Air Permit Review

Facility Data			Permit Applicability (this application only)		
Applicant (Facility's Name): Duke Energy Carolinas, LLC - Dan River Steam Station Facility Address: Duke Energy Carolinas, LLC - Dan River Steam Station 900 South Edgewood Road Eden, NC 27288 SIC: 4911 / Electric Services NAICS: 221112 / Fossil Fuel Electric Power Generation Facility Classification: Before: Title V After: Title V Fee Classification: Before: Title V After: Title V			SIP: 2D .2400 (CAIR), 2Q .0400 (Acid Rain), 2D .0614 (CAM), 2D .2500 (Hg) NSPS: NESHAP: PSD: PSD Avoidance: NC Toxics: 112(r): Other: 40 CFR Parts 72 and 75		
Contact Data			Application Data		
Facility Contact	Authorized Contact	Technical Contact	Application Number: 7900015.08A Date Received: 01/18/2008 Application Type: Renewal Application Schedule: TV-Renewal Existing Permit Data Existing Permit Number: 03455/T27 Existing Permit Issue Date: 08/24/2009 Existing Permit Expiration Date: 01/31/2014

I. Purpose of Application

Dan River 3 1982 - 2007

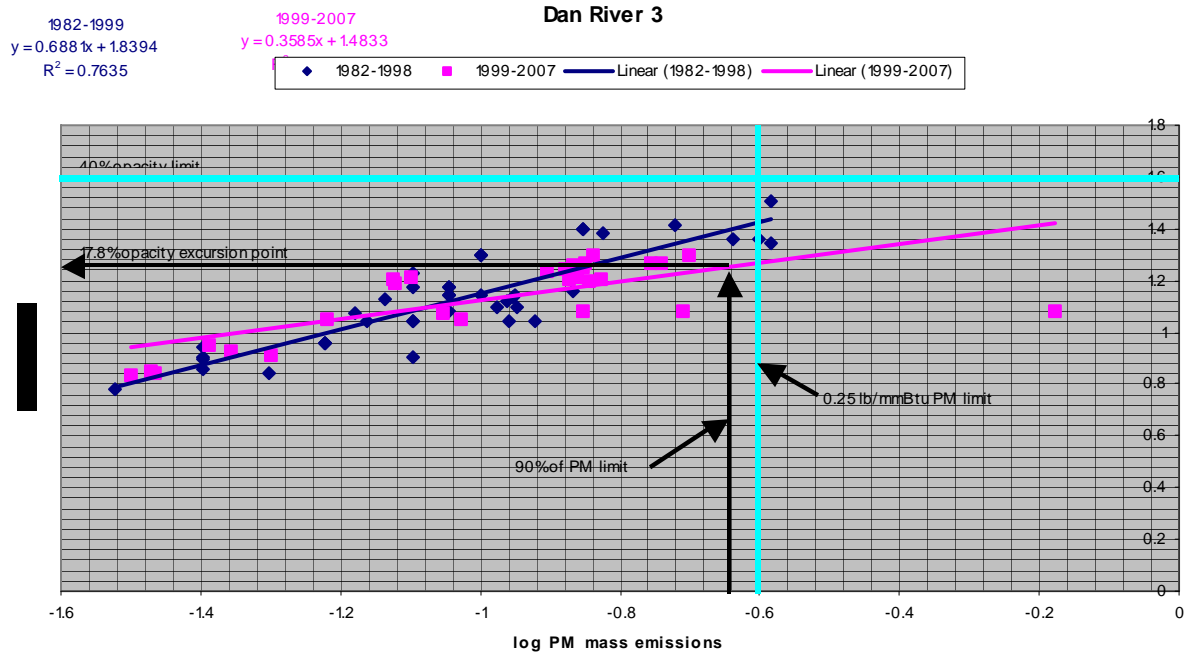
Duke originally proposed an opacity excursion level of 29% for each of the three boilers based on a plot of historical PM mass emissions vs. opacity using data points from annual stack tests (going back as far as 1982) performed to show compliance with the PM limits in 2D .0536. A linear regression of the data was plotted on a log-log scale, which Duke states is most representative of the relationship between PM emissions and opacity for the data, to arrive at a CAM opacity trigger level (excursion point). The point at which the line crosses the PM limit is Duke's proposed trigger level. Duke plotted Boilers 1 and 2 together to provide more data points since these are identical boilers and plotted Boiler 3 separately (for example see plot below for Dan River 3). Duke's method of plotting the data, with PM emissions as the dependent variable on the vertical axis, shows the line crosses the 0.25 lb/mmBtu PM limit at an opacity of 29% (see Table 1, column 1).

However, when plotted correctly with opacity as the dependent variable on the vertical axis, the line crosses the PM limit at much lower opacity values (for example see plot below for Dan River 3).

DAQ has used the most recent approximately 10 years of data (1999-2007 in the Dan River 3 plot above) to determine the opacity that provides a reasonable assurance of compliance with the emission limitation. An opacity value is selected based on EPA's proposed CAM Technical Guidance: *CAM Protocol for an ESP Controlling PM from a Coal-Fired Boiler*. This guidance recommends that the indicator range for opacity be established at a level equal to or less than an opacity at which the source has demonstrated a margin of compliance with the PM emissions limit of at least 10%. Therefore, at equal to or less than the PM limit, DAQ determined the opacity for Dan River 3 to be 17.8% (results for all boilers shown in column 2 of Table 1).

% Opacity				
	1	2	3	4	5
Boiler	Originally Proposed by Duke	DAQ's analysis using 1999-2007 opacity-PM log-log plots	Duke's proposal using 4 yrs of 3-hr at 2% of quarterly exceedance of CAM excursion	DAQ's analysis using last 4 yrs of 3-hr data at 5% quarterly exceedance of CAM excursion	Final CAM excursion point
U-1	29	7.6	14.5	10.4	14
U-2	29	8.3	19	15.6	18
U-3	29	17.8	27	14.1	18
